# FINAL DRAINAGE REPORT FOR CLAREMONT BUSINESS PARK 2 FILING NO. 2 EL PASO COUNTY, COLORADO

Project #10-020  
PCD Filing No.: VR233 k

**FINAL DRAINAGE REPORT FOR CLAREMONT  
BUSINESS PARK 2 FILING NO. 2  
EL PASO COUNTY COLORADO**

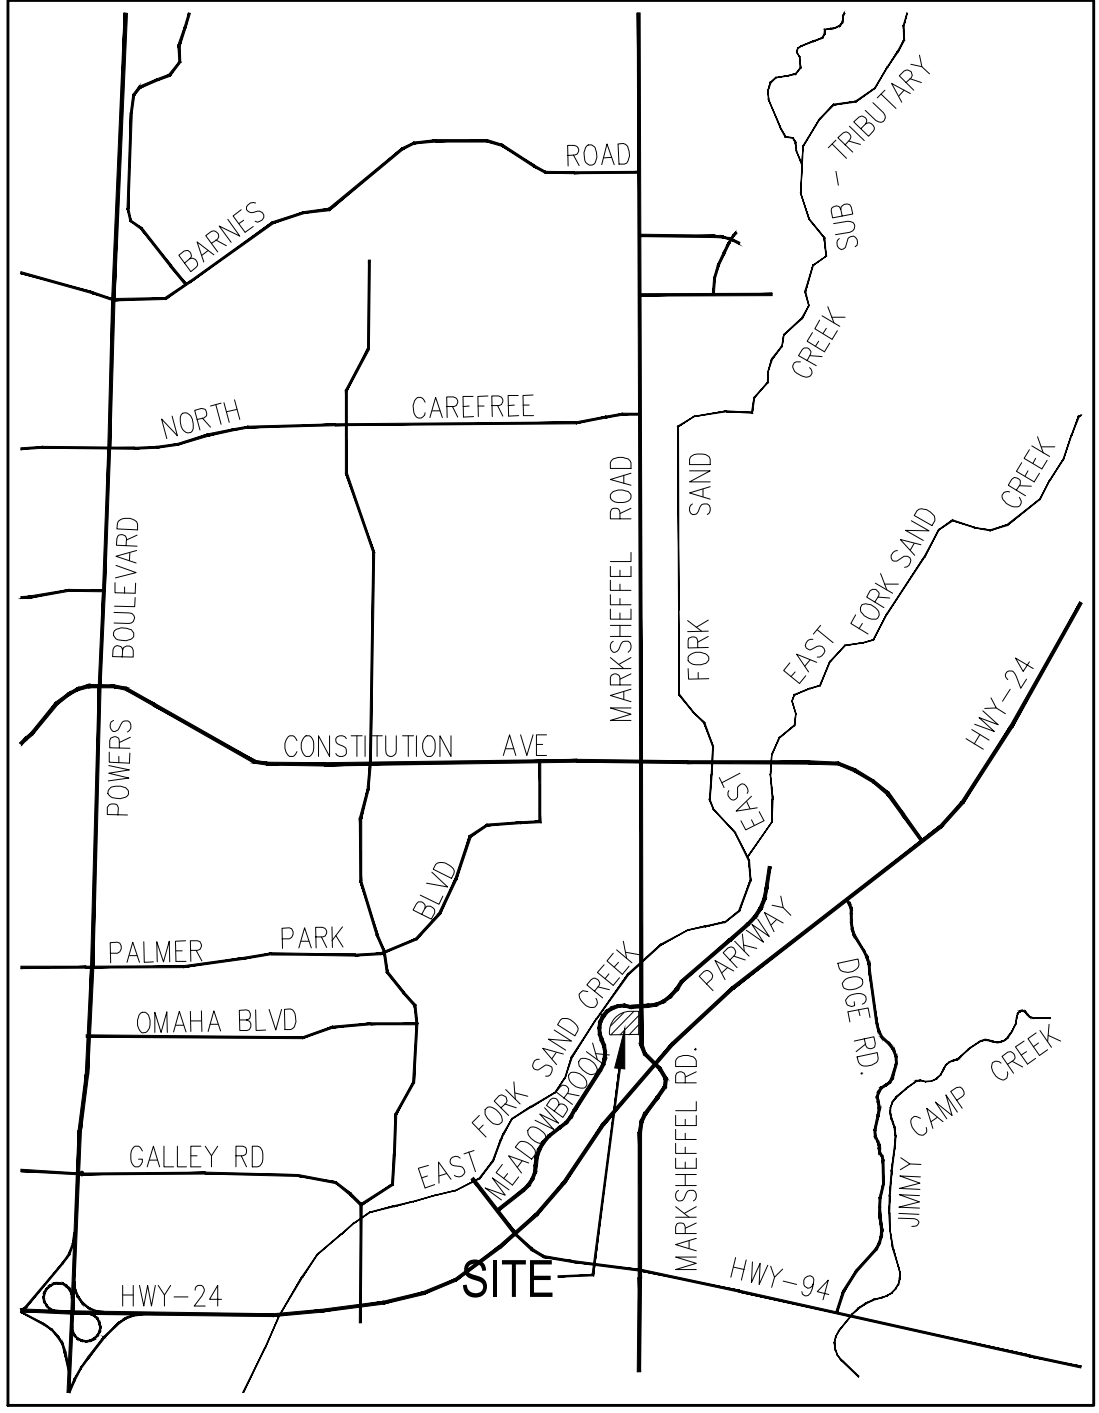
delete this column if no RR is anticipated for this site.

Add rows for each basin within this filing.

Make a column for each of the 5 ponds.

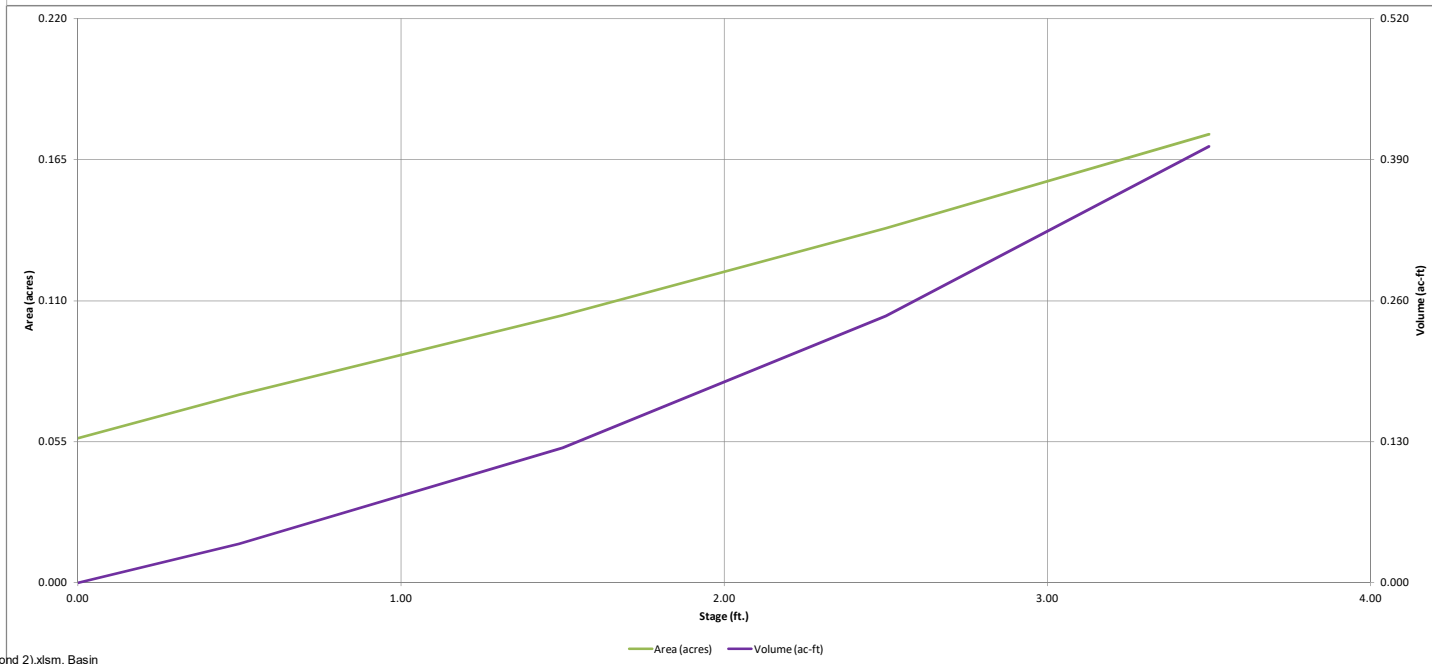
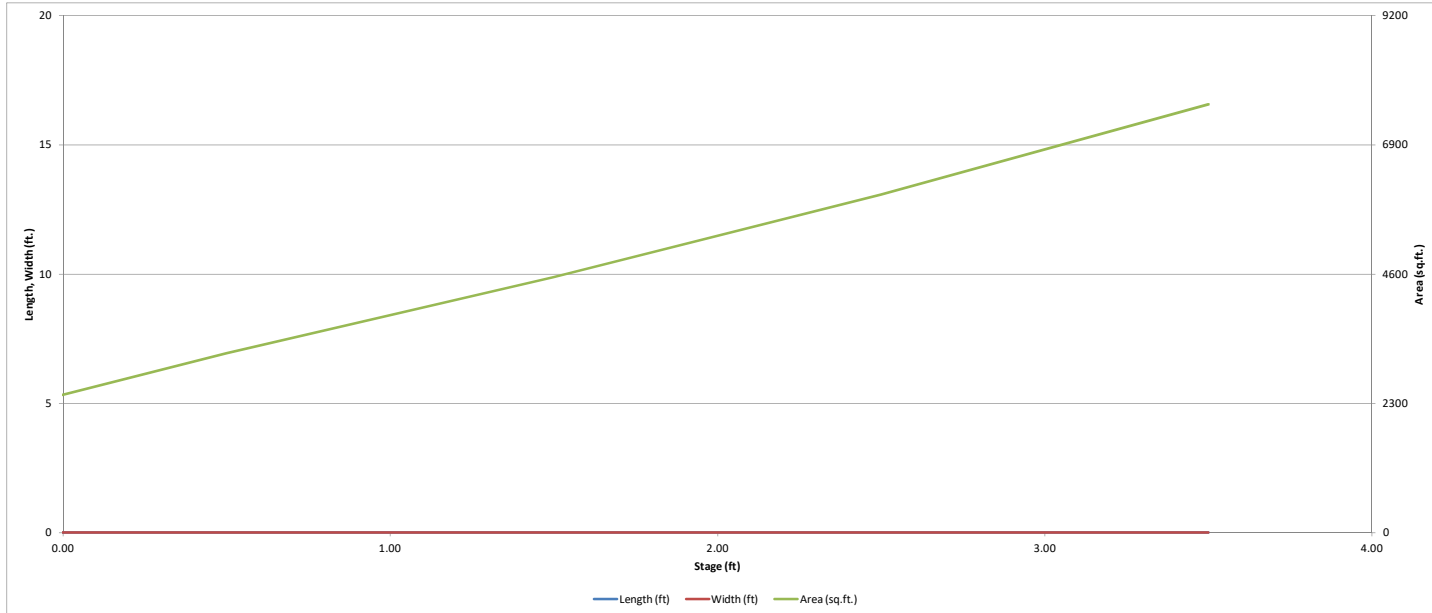
Add text to the PDF at the top of all calc sheets of ponds that aren't to be constructed with this project (ie: just the roads and Pond 3) that these "CALCS PROVIDED FOR INFORMATION ONLY, POND # [insert "1," "2," "4", and "5" as appropriate] TO BE DESIGNED AND CONSTRUCTED WITH FUTURE DEVELOPMENT"

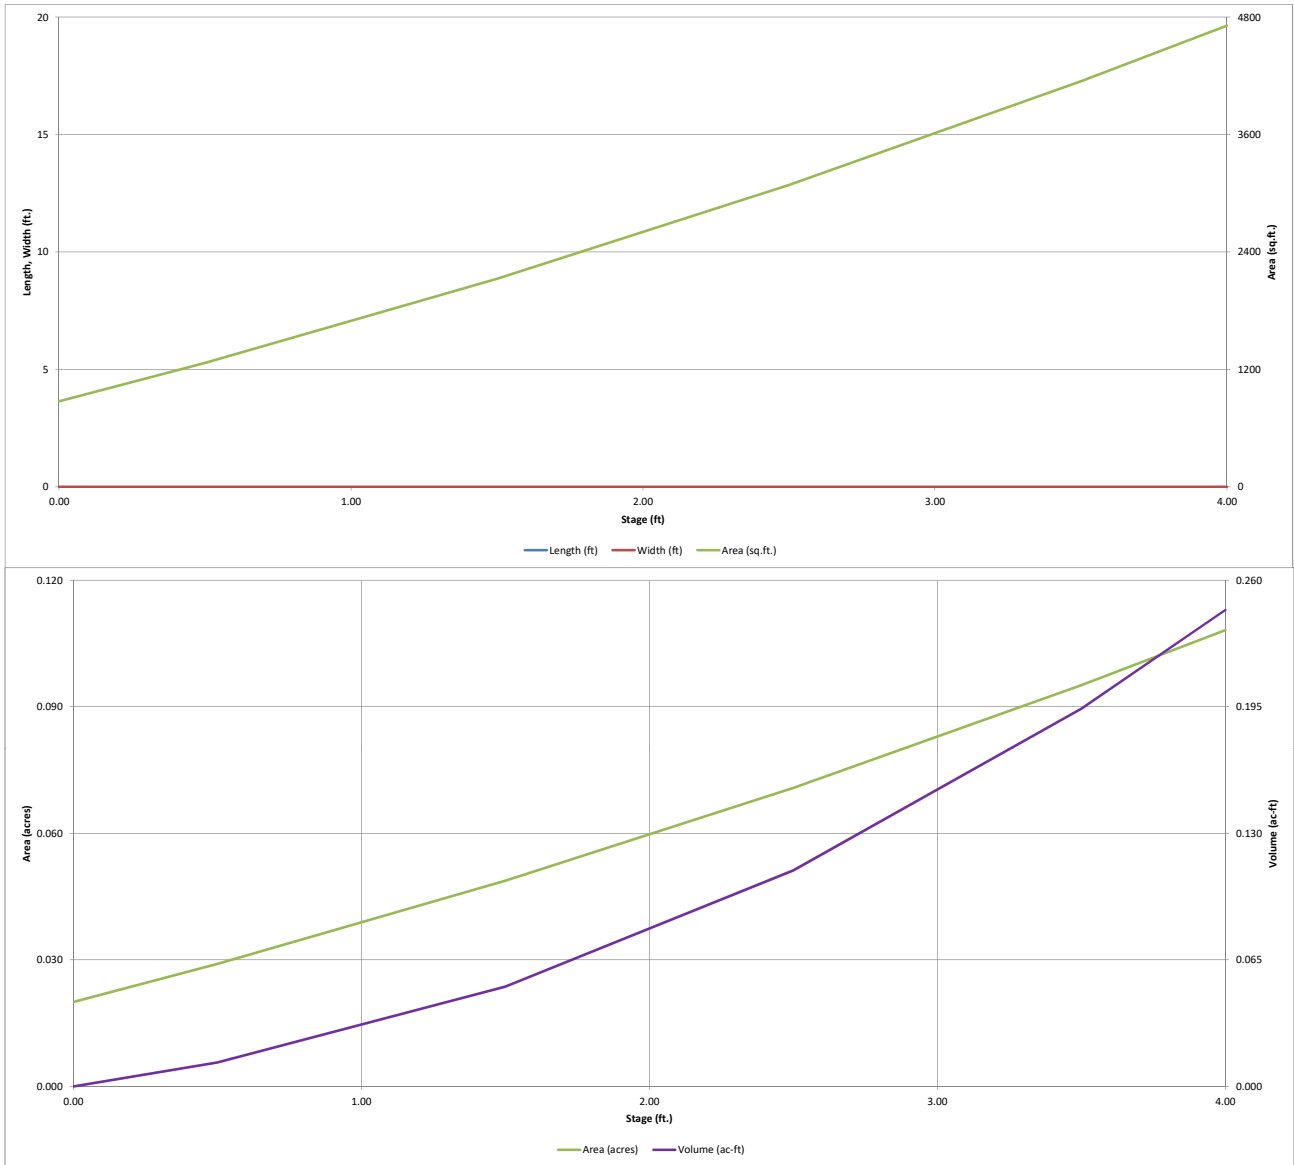
Add text to the PDF at the top of all calc sheets of ponds that aren't to be constructed with this project (ie: just the roads and Pond 3) that these "CALCS PROVIDED FOR INFORMATION ONLY, POND # [insert "1," "2," "4", and "5" as appropriate] TO BE DESIGNED AND CONSTRUCTED WITH FUTURE DEVELOPMENT"

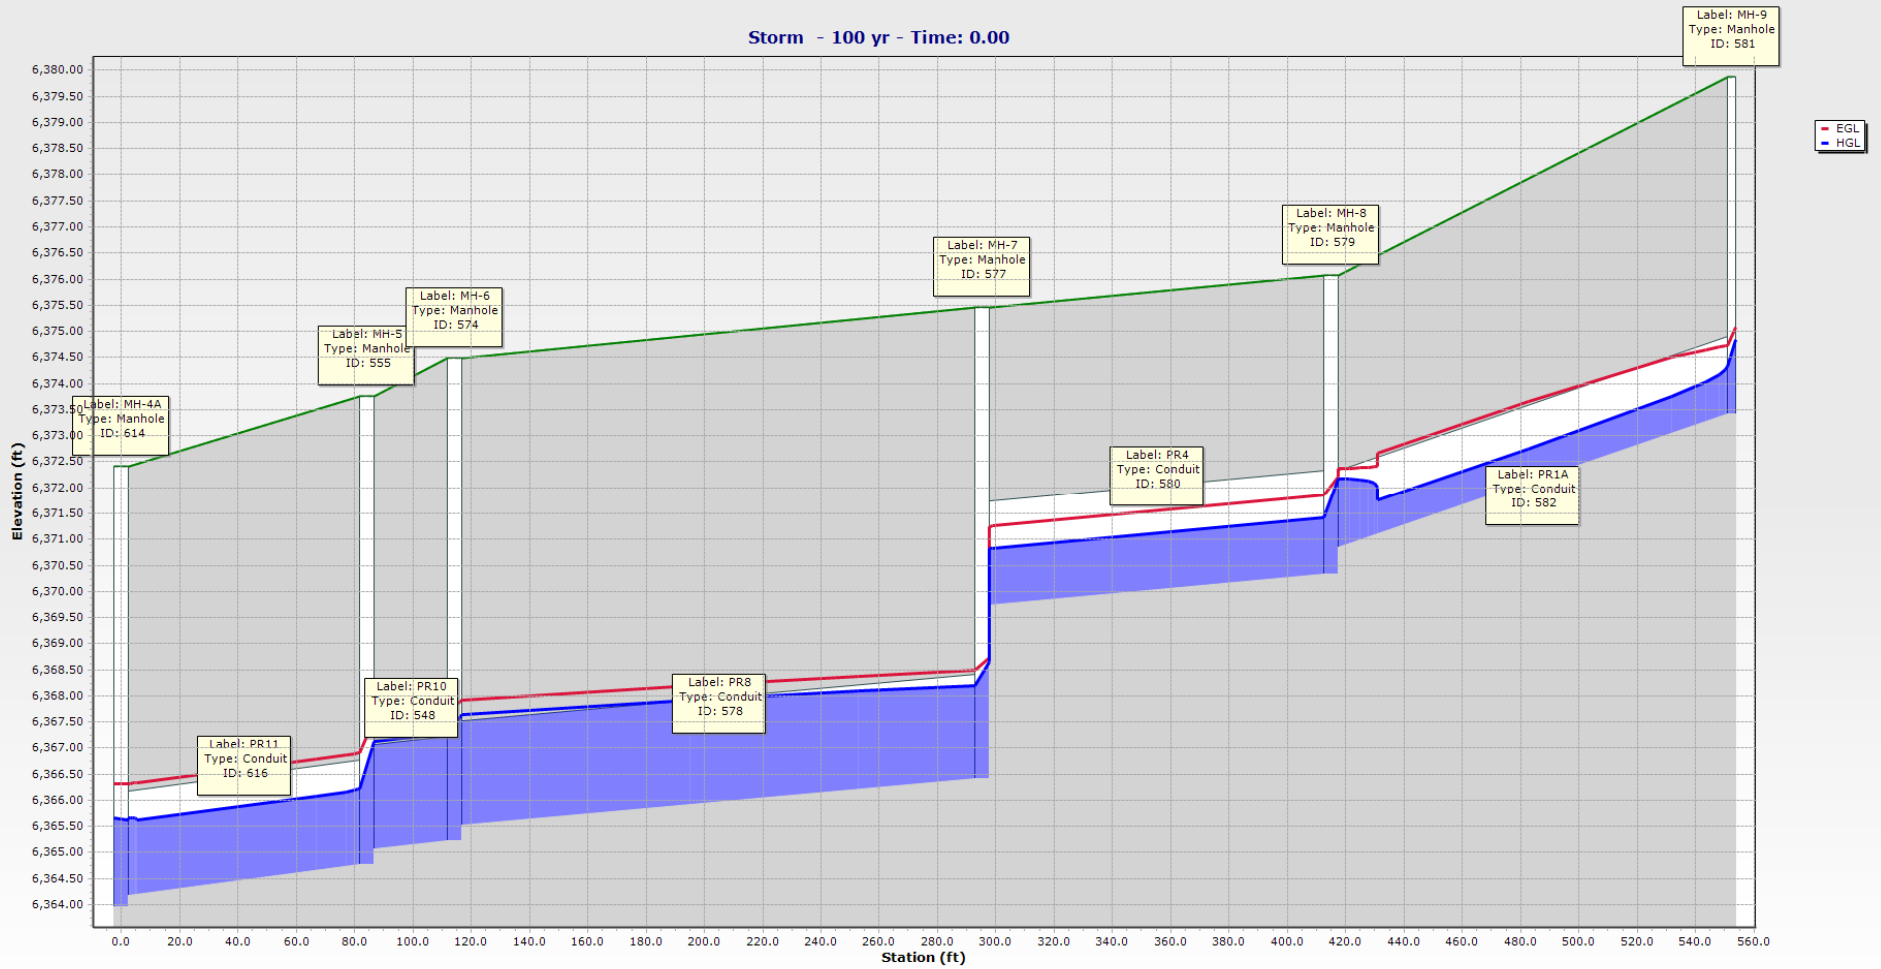
Try to print all of stormcad table on one sheet, or include "Label" column with second sheet

Include pipe slope in table. ID, Fr #, % Flow/Capacity, critical depth, & EGL's is not needed in table.

## EXISTING CONDITIONS DRAINAGE MAP

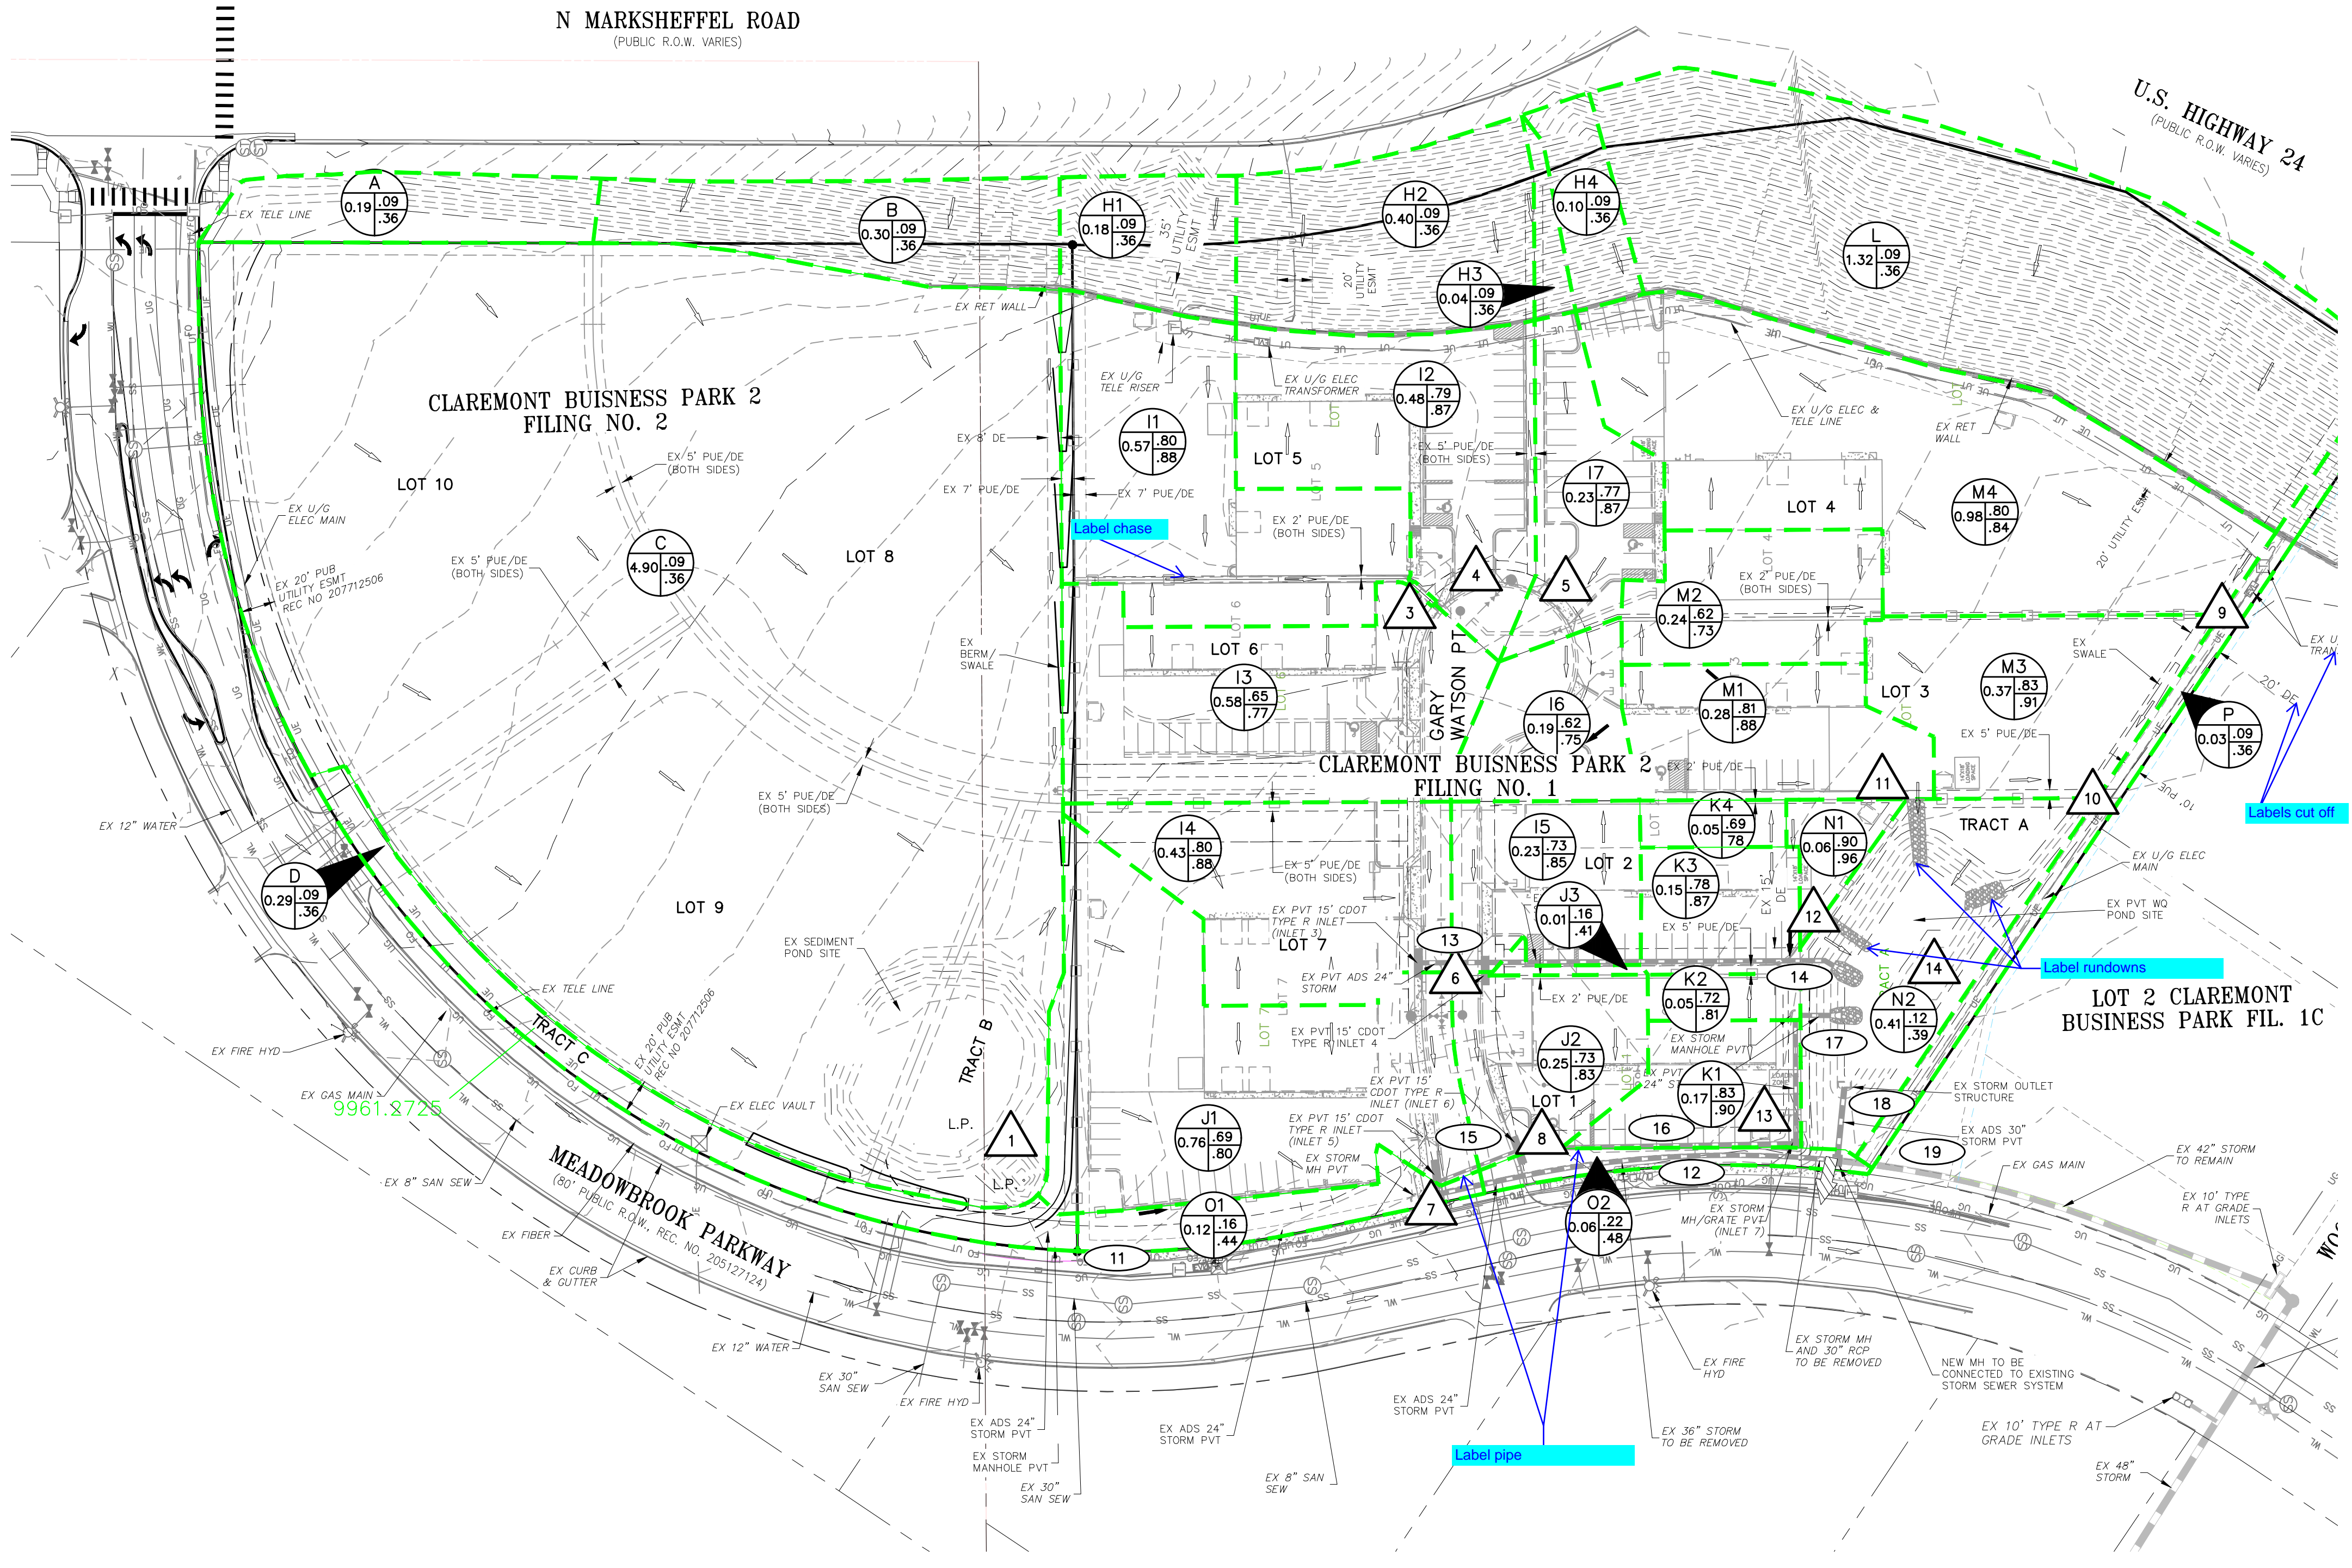
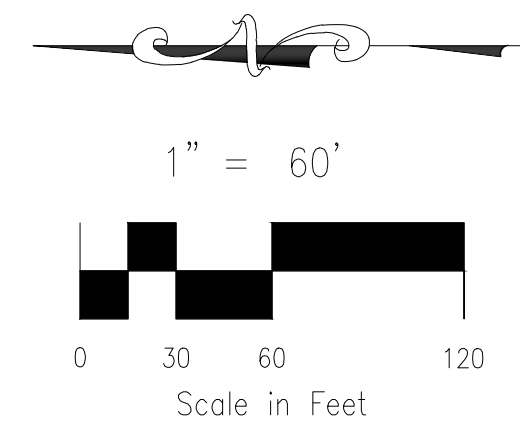
Add Contour Labels

Label rundowns

Label pipe

Label chase

DESIGNED BY: DLM SCALE: DATE: 02-24-2023  
 DRAWN BY: DLM HORIZ: 1"=60'  
 CHECKED BY: VAS VERT: N/A SHEET 1 OF 1 PDM01

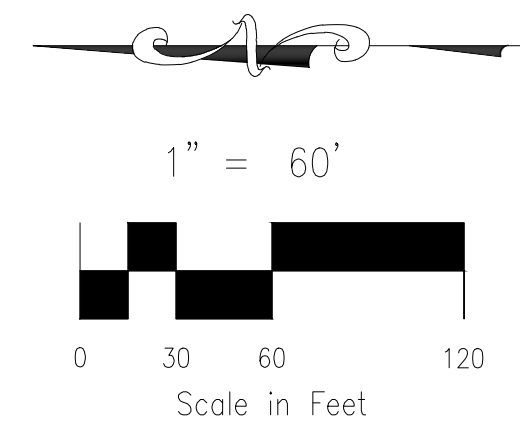
Show riprap

-Add contour labels  
 -Indicate if facilities are public or private
